SERVICE BULLETIN

Subject: Chafing of Aileron Cable Assembly P/N 7227151-522WE.

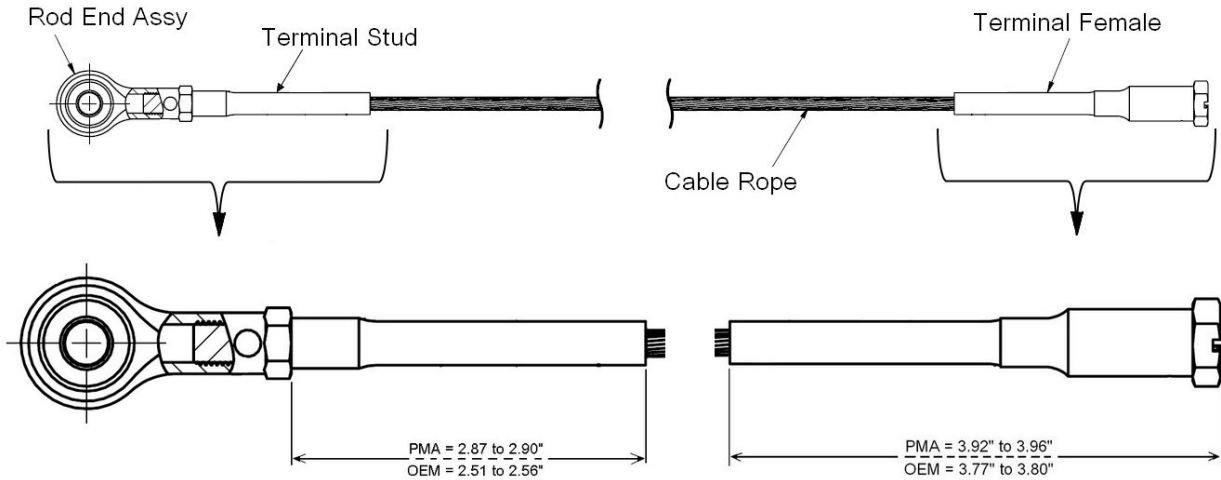
A SAAB 340 operator has reported instances of chafing wear damage on Wencor PMA aileron cables P/N 722151-522WE. The wear was observed during a line maintenance inspection. Upon subsequent inspections, the operator reported finding several more instances of chafing wear damage in their fleet, for a total of five (5) cables exhibiting signs of chafing wear damage. In all instances, the wear affected cables were installed in the forward outboard position at locations where the cables pass through the fairleads as shown below.

Chafing wear damage is dependent upon the installed location of the aileron cables. If the cable passes through a fairlead as in the case of the forward aileron cable run, chafing wear is possible. However, the aft aileron cable run does not pass through any structure, therefore cables installed in this location may not experience chafing damage.
